M E M O R A N D U M

SUBJECT: **SP24-012: Parker Central Area F5 L2 B1 - McDonalds– Site Plan Amendment**
Review Comments 03

SITE DEVELOPMENT PLAN
MCDONALDS REMODEL AT PARKER CENTRAL AREA
FILING NO. 5, BLOCK 1, LOT 2

SHEET NO:
LI1.0

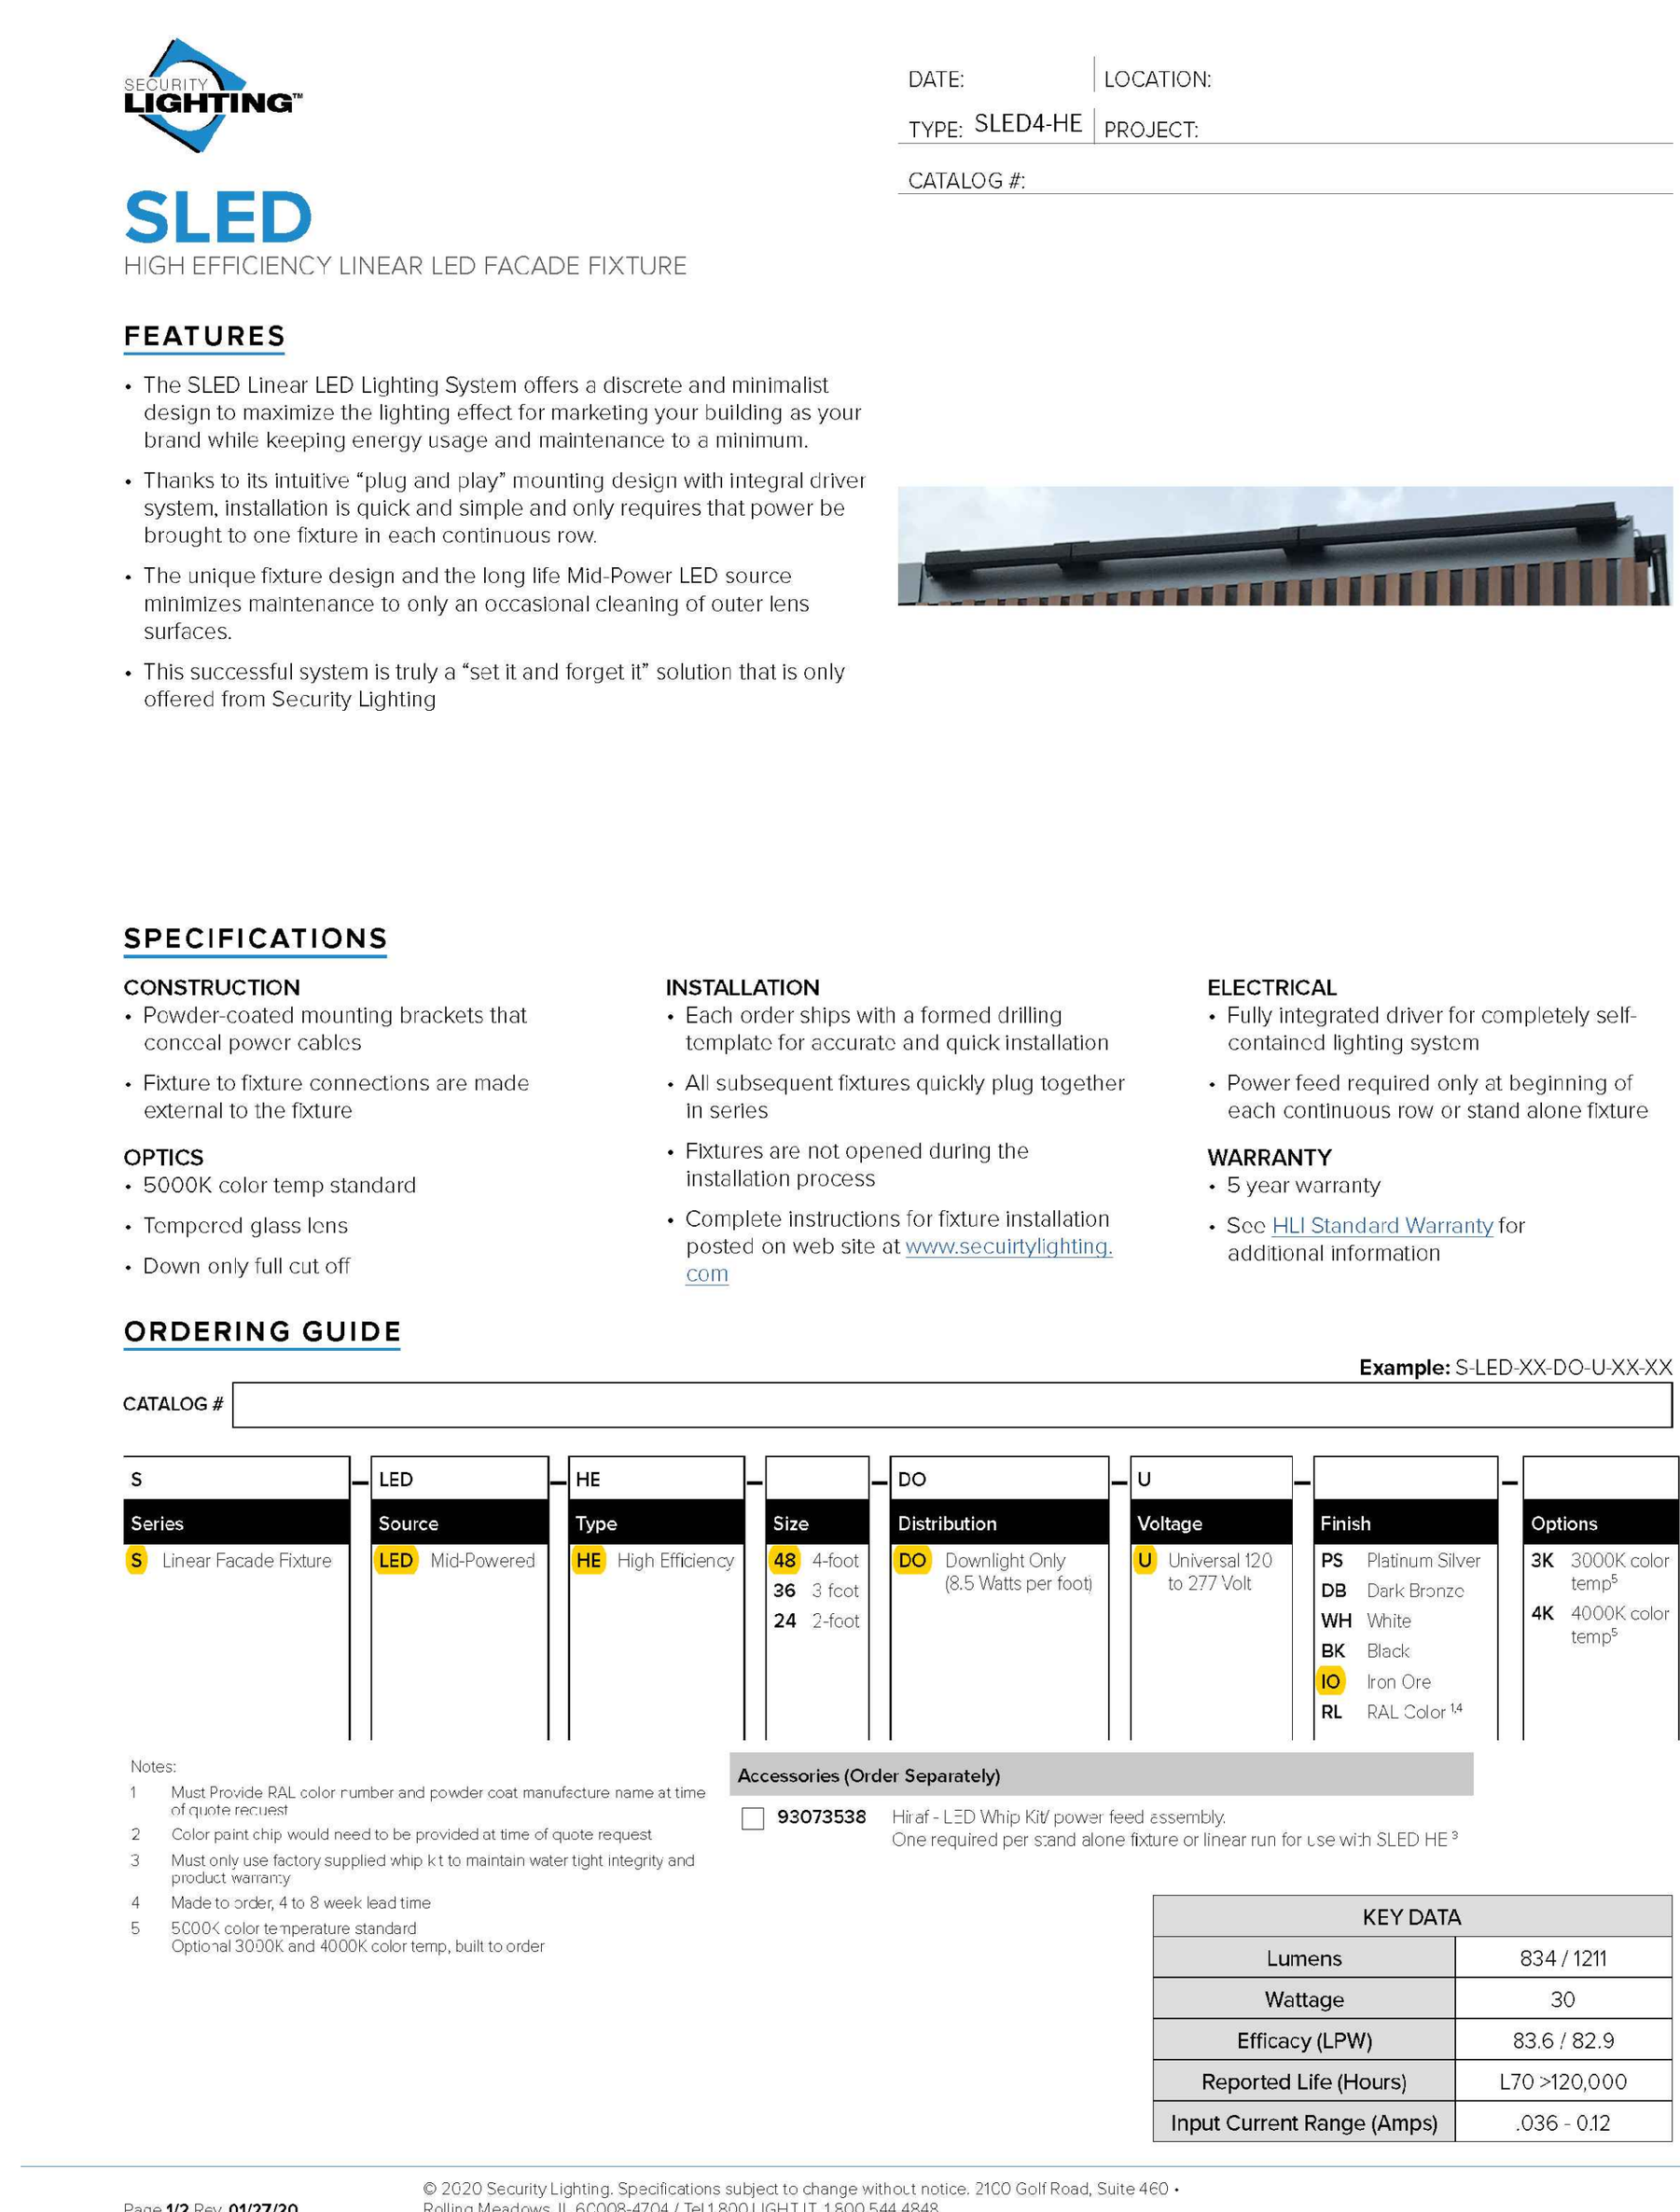
Update table. Per LDO Administrative Manual Section B.2.(f). Photometric Plan needs to include a table with the following information: light fixture,name, label, height, fixture color, total lumens, lighting type - CCT. CCT shall be below 5001 Kelvin.

2 EAST ELEVATION
SCALE : 3/16" = 1'-0"

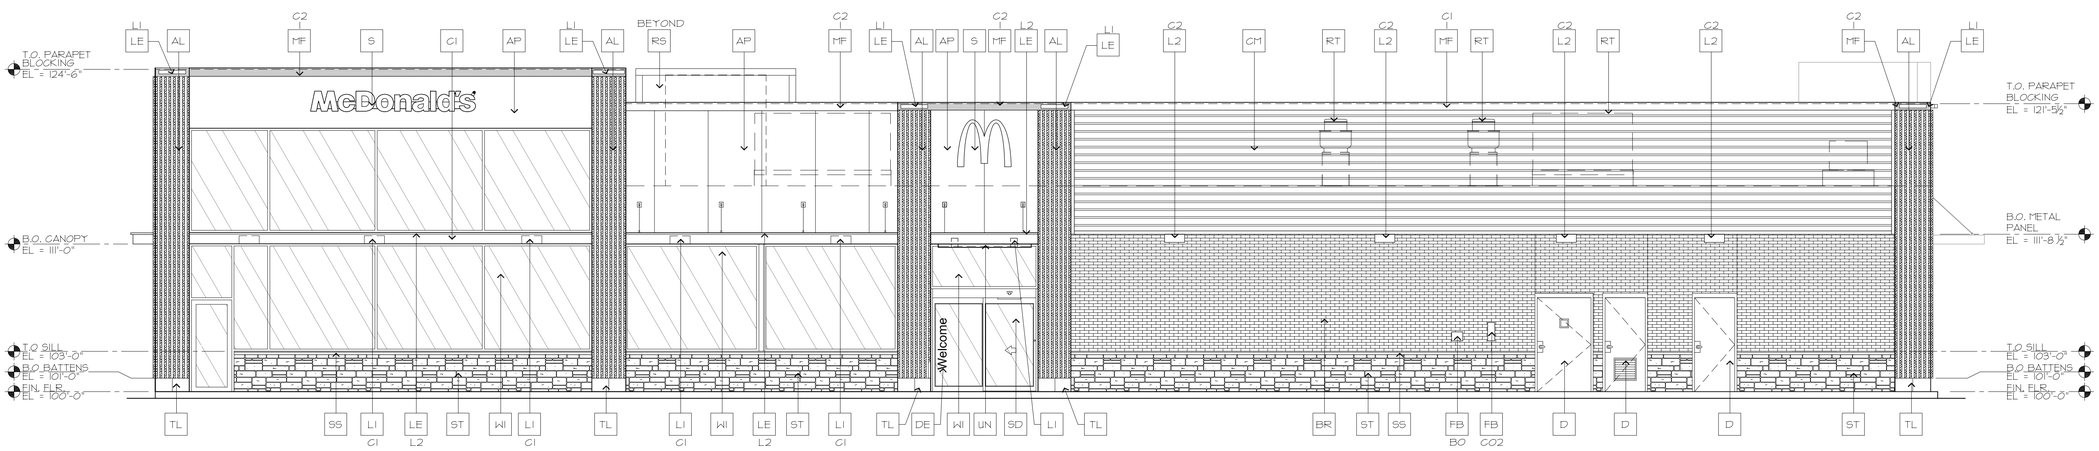
Everything Community Development is reviewing needs to be on these plans. Show guard rail on elevations and this site plan.

1 NORTH ELEVATION
SCALE : 1/4" = 1'-0"

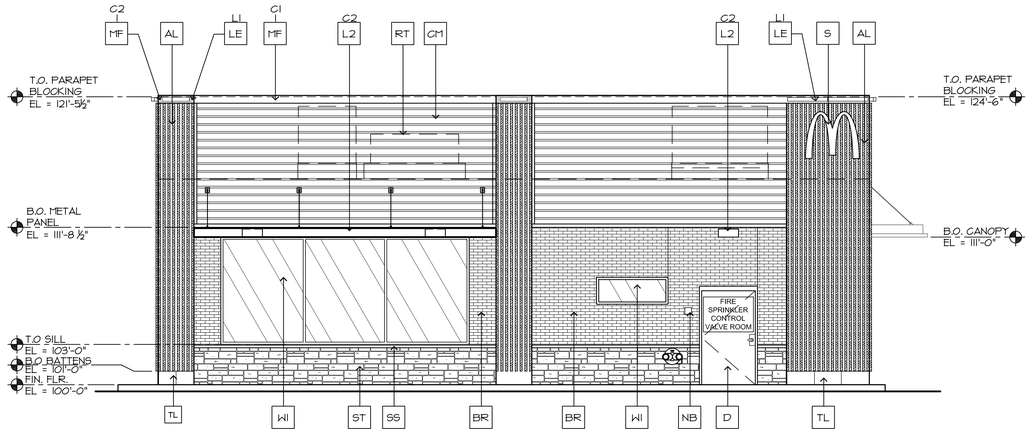
Per DDS X.A.2.c.i. 1-2, show transparency calculations for all facades.

Show wall-mounted electrical equipment, add note that it will be painted to match adjacent wall.

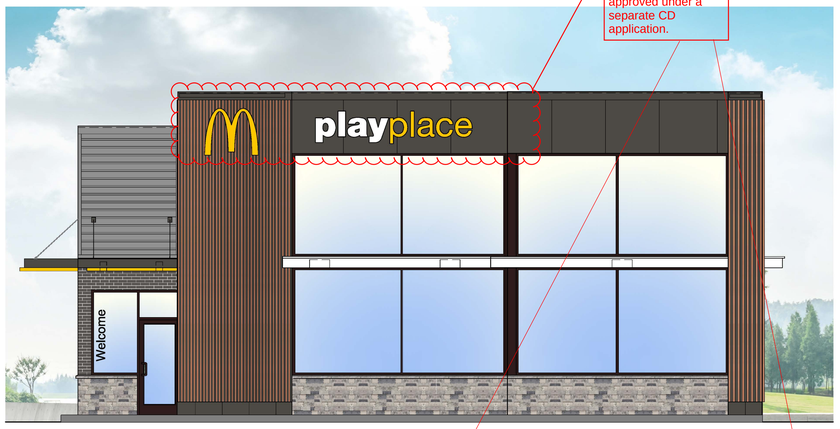
Remove or note that not part of this Site Plan and will be approved under a separate CD application.

Label material on elevations.

Provide a material board to the Planning Division Office.
